## A-Frame Additional Support

<b>Bulletin Type:</b>	Technical Service Bulletin TSB	<b>Publication Date:</b>	April 23, 2021
<b>Bulletin #:</b>	20-025	<b>Make(s):</b>	Starcraft
<b>Job Code:</b>	9802517	<b>Model(s):</b>	GPS
<b>Flat Rate:</b>	1.5 Hours	<b>Model Year(s):</b>	2018

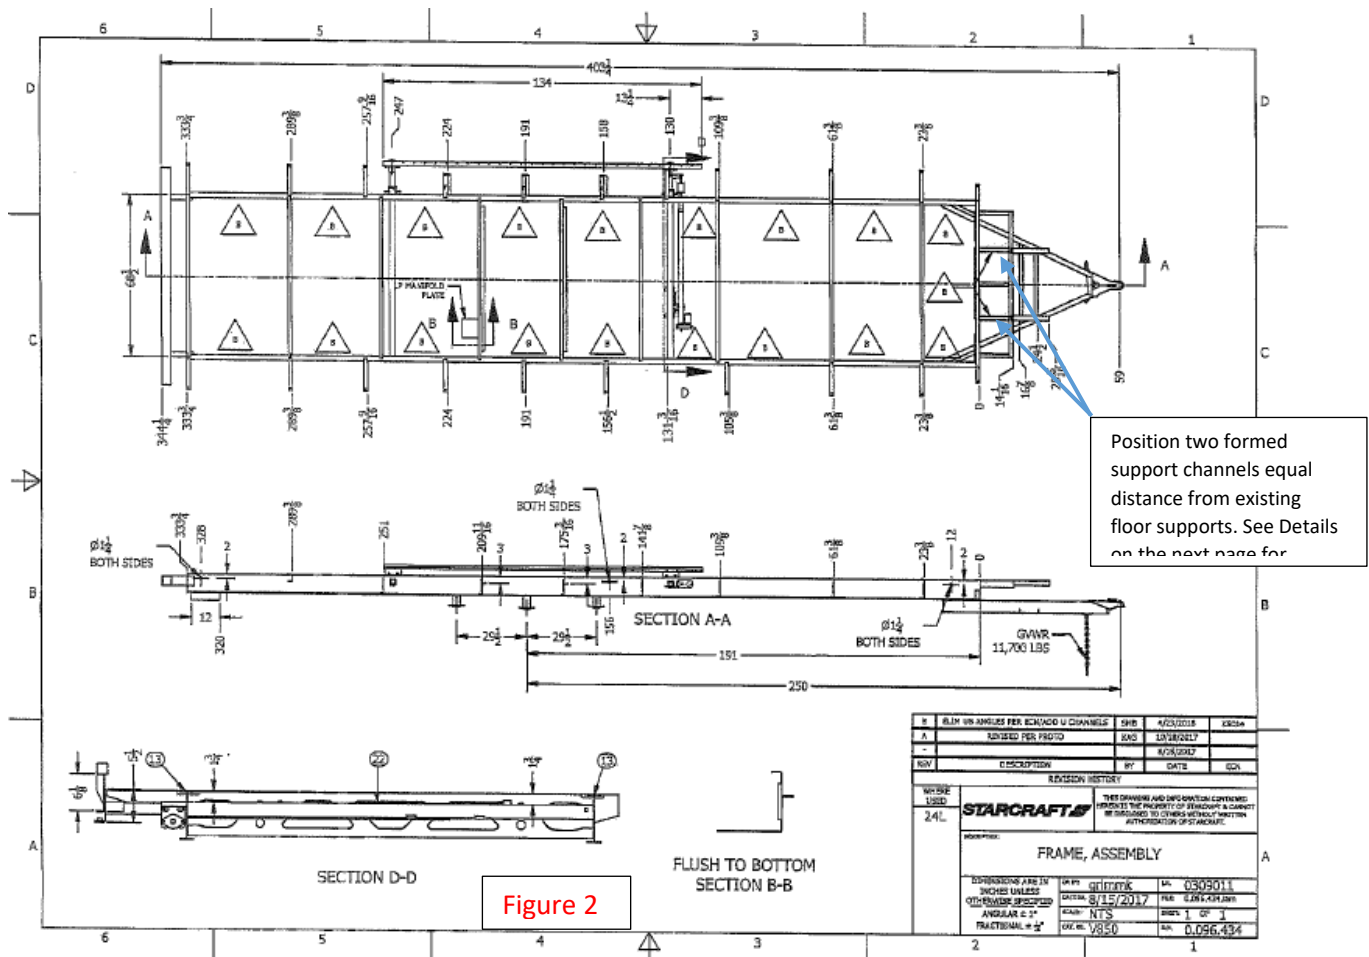
- Verify the VIN is in the TSB scope. All affected units require this remedy. #1
- Inspect unit for missing floor supports in frame and any signs of stress cracks at corner radius of fiberglass. #2

Step 3: Confirm two floor support channels - 3" tall x 1 1/2" flange x 1/16" thick x 14" Length

Step 4: Measure placement of c-channels and prep area for welding by grinding or sanding paint from frame member.  
Picture #5

Figure 3

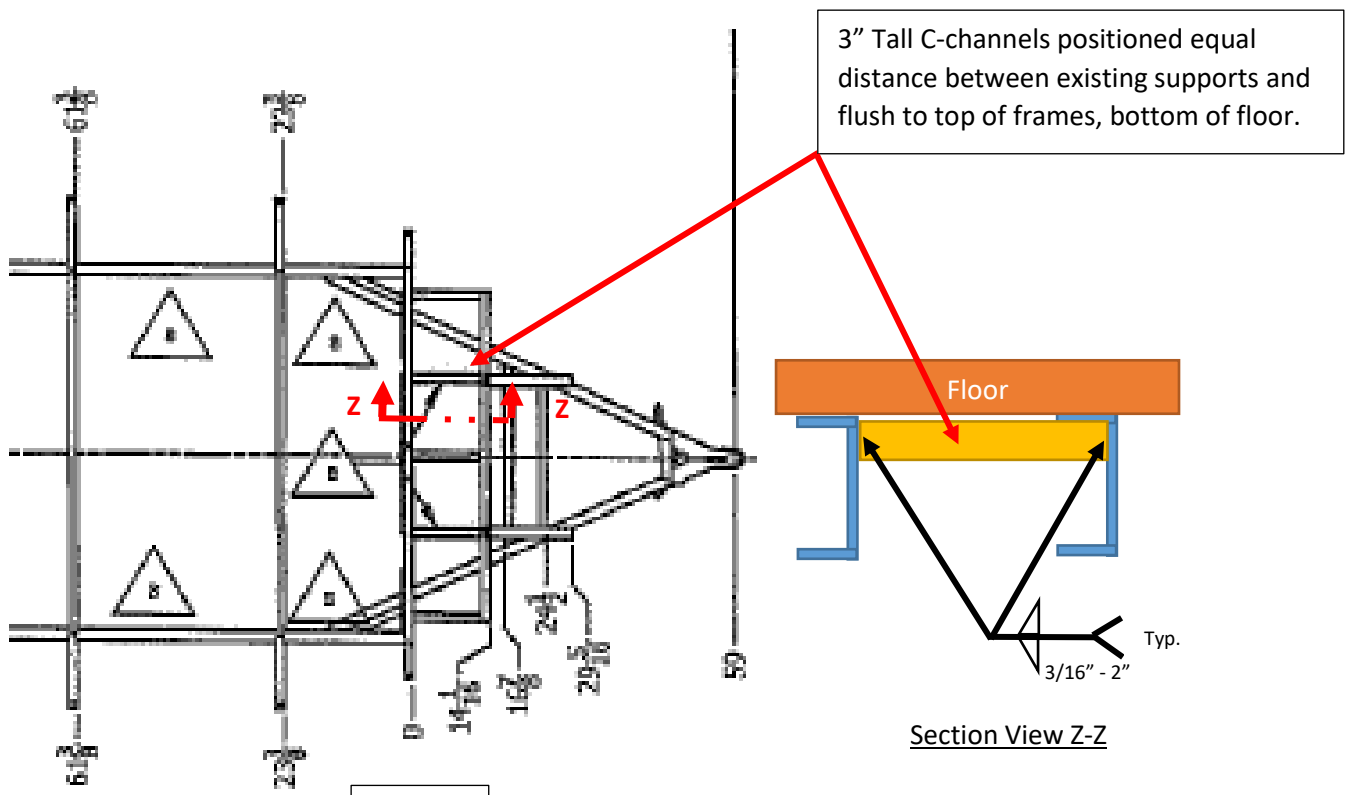
Step 5: Position c-channels equal distance between existing supports as shown in Figure 2. Raise the 3" c-channels upward and position flush to top of frames, bottom of floors as shown in section view Z-Z page 6. Clamp c-channels into position.

Step 6: Weld the two 3" c-channels into position as shown in figure 3 and section View Z-Z shown below.
